## **Technical Service Information**

# FORD A4LD CENTER SUPPORT INTERCHANGEABILITY

Figure 1

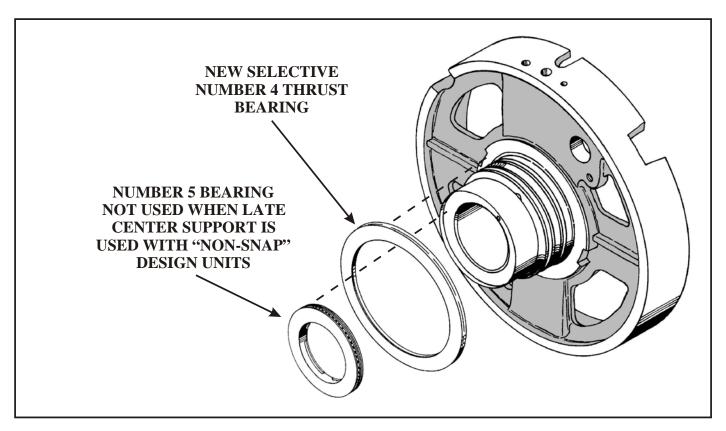
(1) NUMBER 4 THRUST WASHER - Was replaced by a new <b><i>selective </b></i>Number 4 thrust bearing, as shown in Figure 1.

<B><i>Note: </b></i>The number 5 thrust bearing is not used on early "Non-Snap Design" models. Refer to Figure 1.

The late model snap design center support will retro-fit back to early design units as long as the new <b><i>selective</b></i> Number 4, and the Number 3 thrust bearings are used (See Figures 1 & 2).
